02-23-20025 Airport Building Sewer Line Questions & Answers

Date:1/10/2024

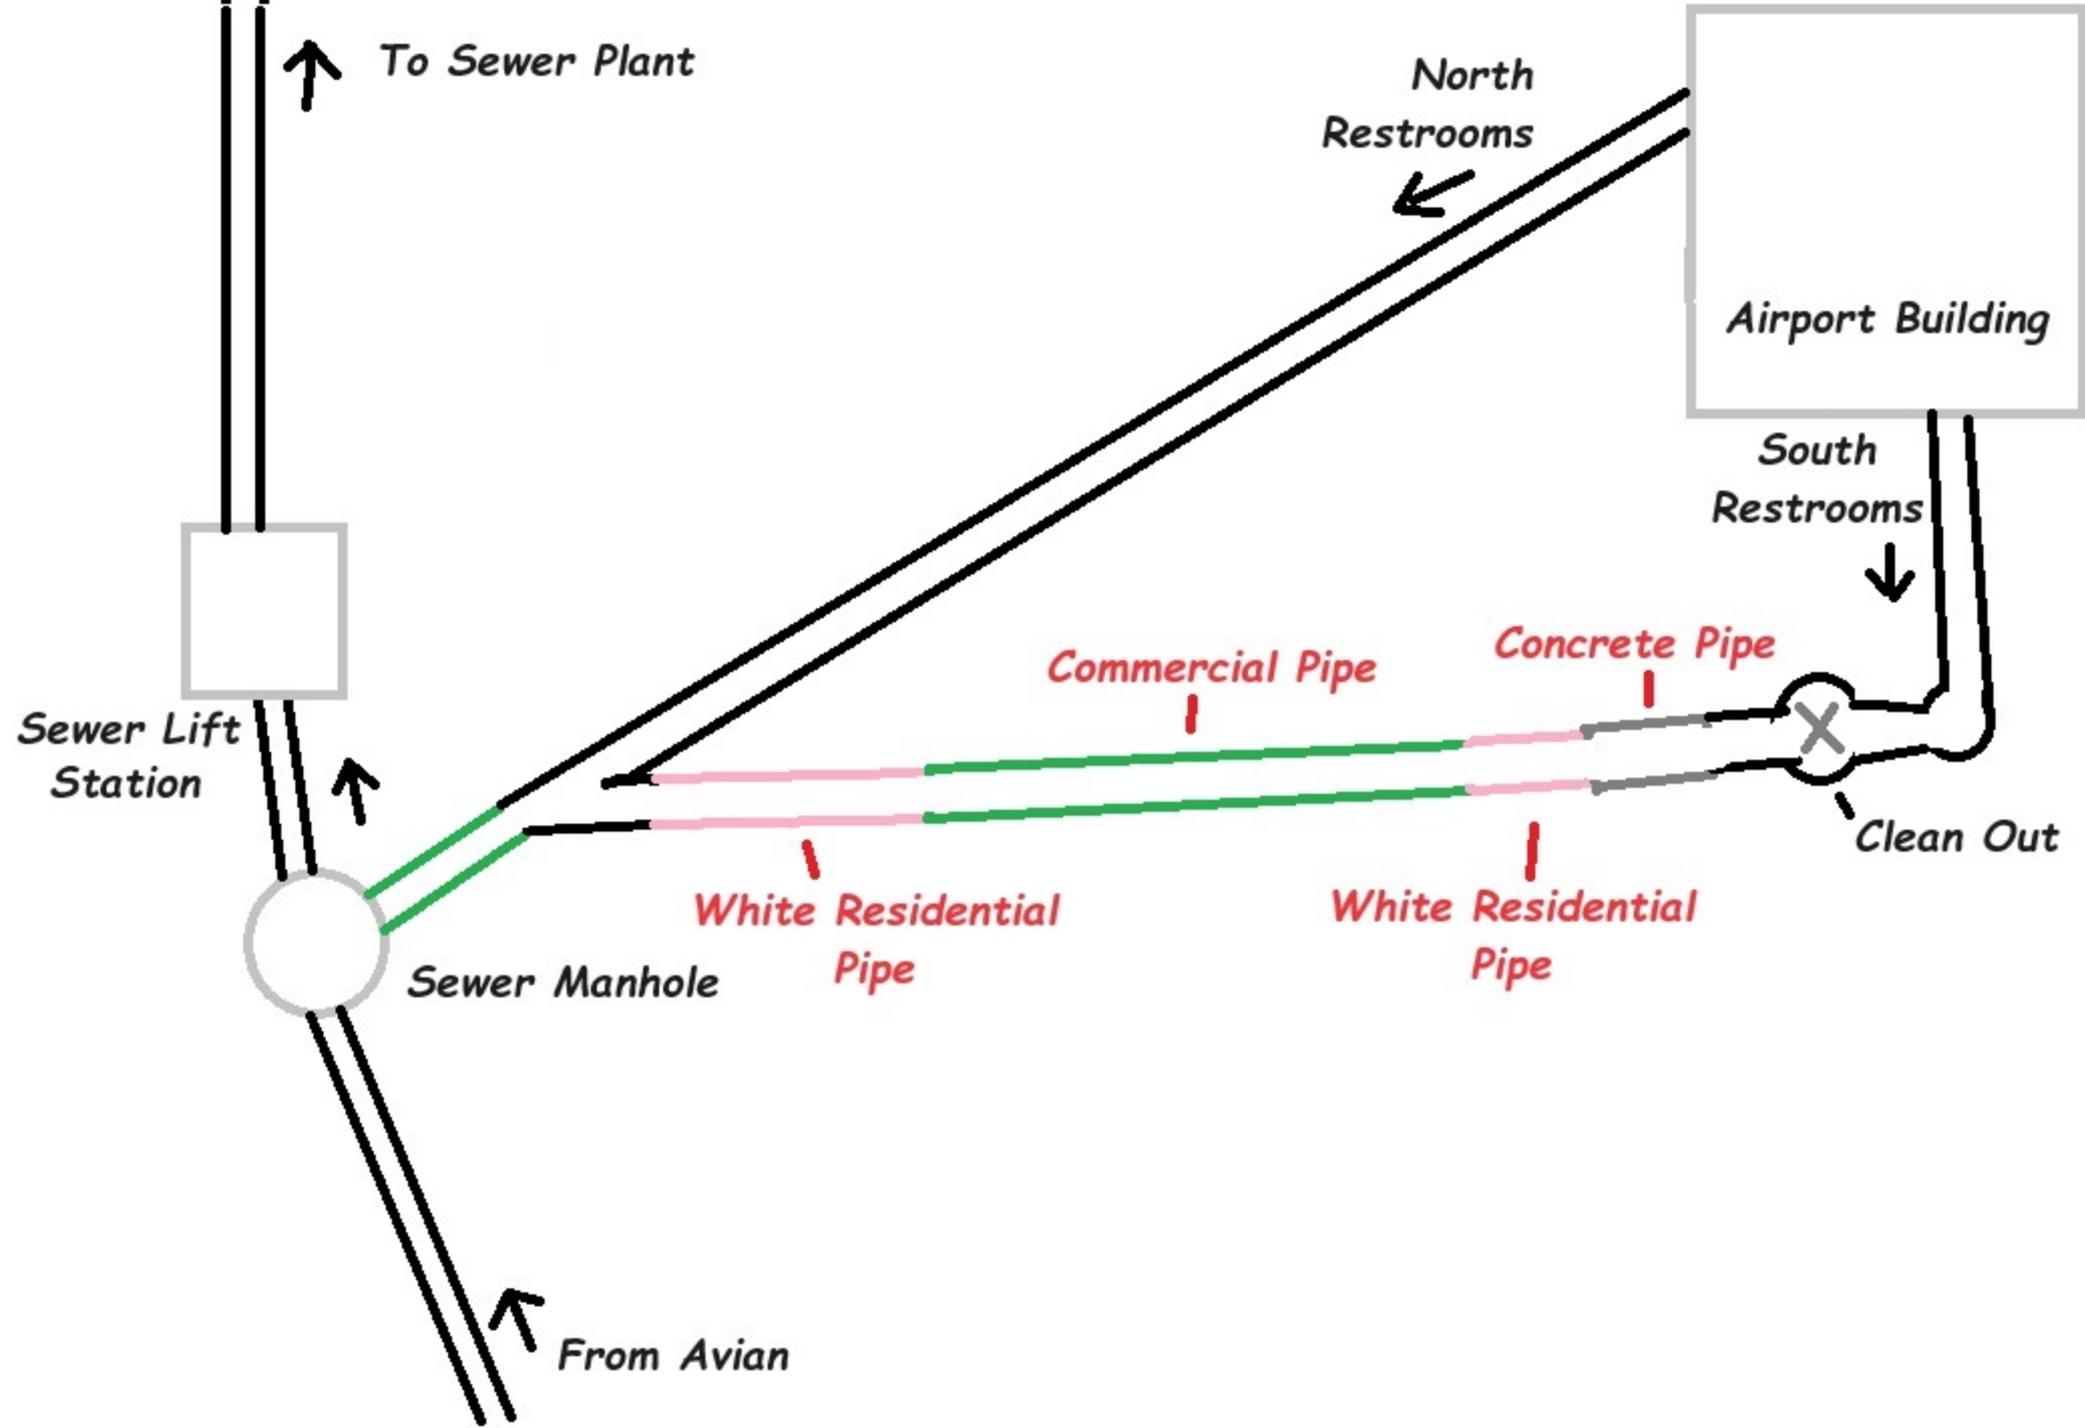
7. Question: Does the new sewer connect to the sewer manhole as shown in provided sketch or to the pump station or the sewer lift station as mentioned in the paperwork?

Answer: The new line will need to connect directly into the lift station vault.
